SUBJECT: **Response to On-hold Letter for Section 401 Water Quality Certification and Jordan Lake Watershed Riparian Buffer Authorization Application** for the replacement of Bridge No. 161 over North Prong Stinking Quarter Creek on SR 1124 (Stafford Mill Road), Alamance County, North Carolina. Federal Aid Project No. BRZ – 1124 (5), TIP No. B-4401.

Per your on-hold letter, dated February 25, 2013, the N.C. Department of Transportation (NCDOT) has reviewed the permit application packet and addressed the issues that you had identified. Revisions resulting from this review include the following:

Buffer Drawing
Sheet 1 of 5
Revised March 2013

Buffer Drawing
Sheet **2** of **5**
Revised March 2013

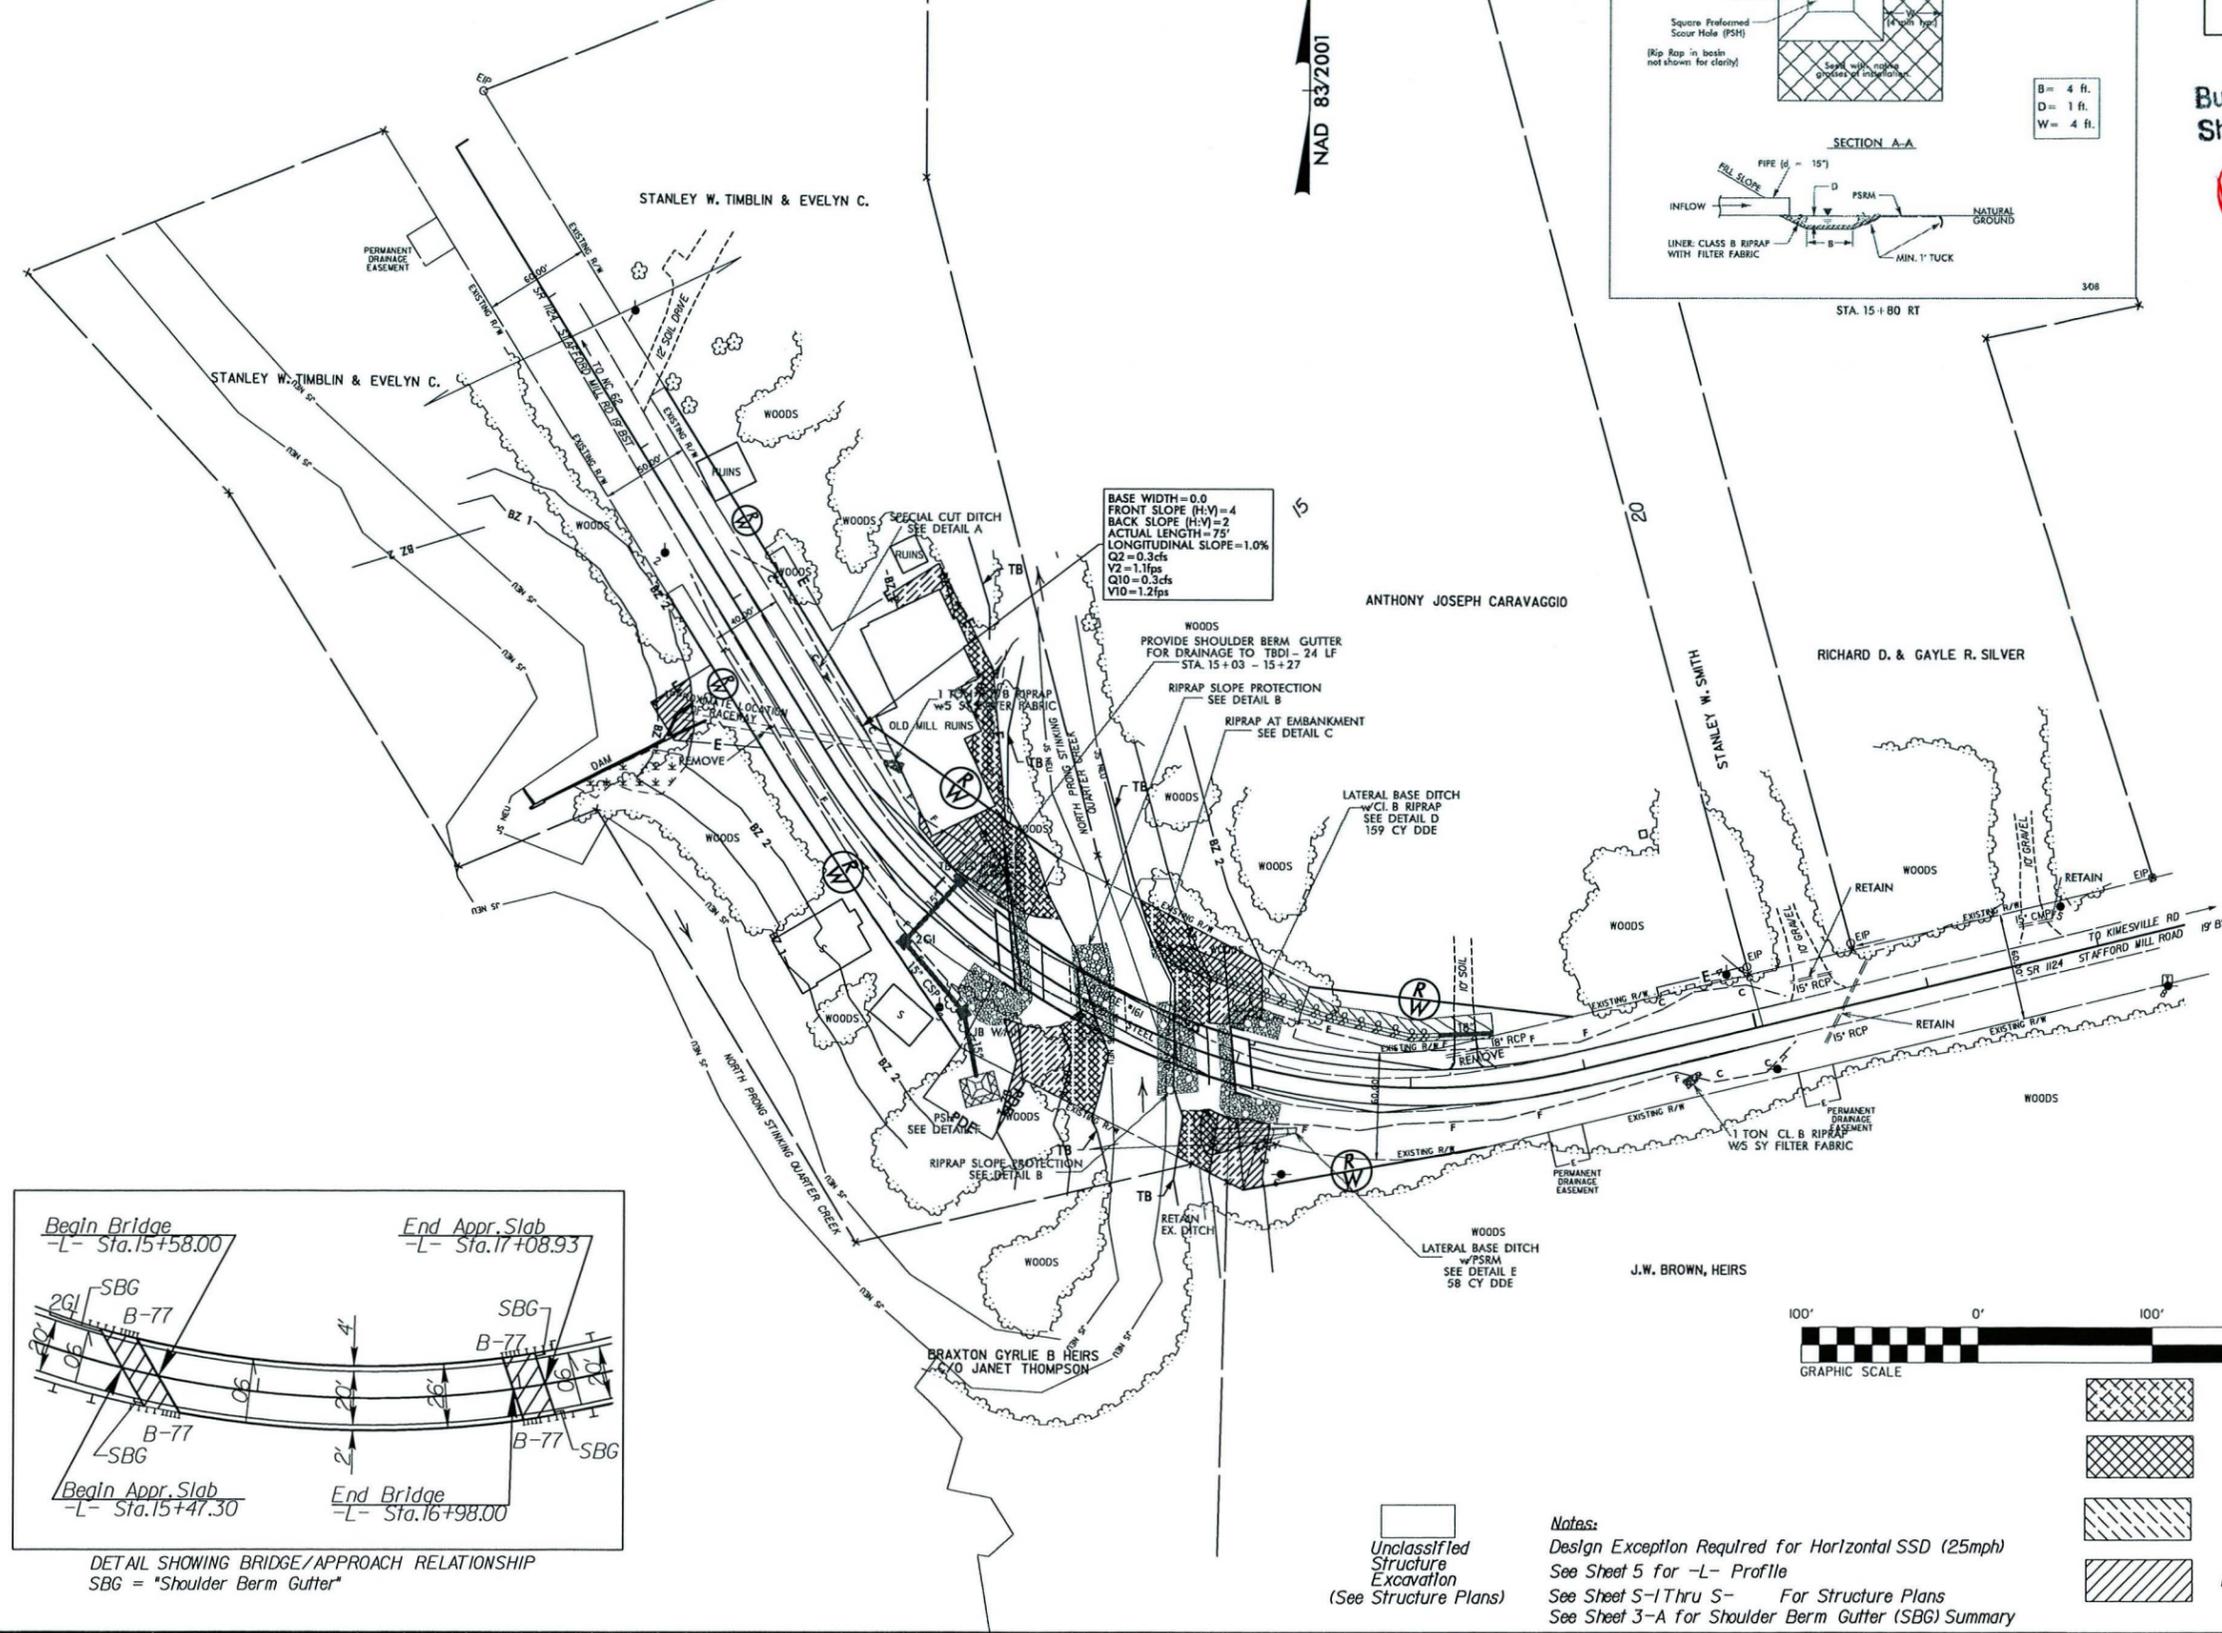
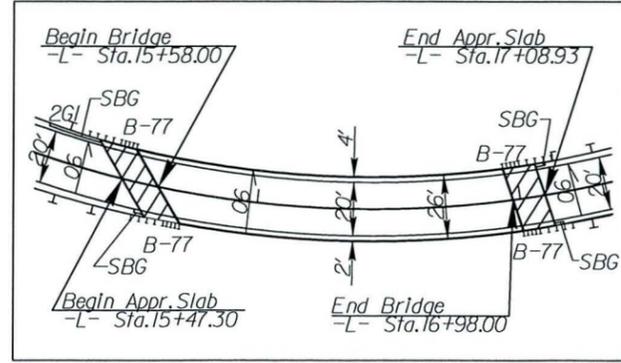
- The buffer drawings were revised because, after review, it was determined that the buffer impacts resulting from two lateral base ditches should have been considered “Mitigable” along their entire length; however, the portions of the ditches that ran through the “Bridge” buffer impact zone were considered “Allowable” in our original permit application. The hatching for these impacts has been updated on the buffer drawings to reflect this change and the buffer impacts have been updated on the buffer impact summary sheet and in the Pre-Construction Notification (PCN).

- ALLOWABLE IMPACTS ZONE 1
- MITIGABLE IMPACTS ZONE 1
- ALLOWABLE IMPACTS ZONE 2
- MITIGABLE IMPACTS ZONE 2
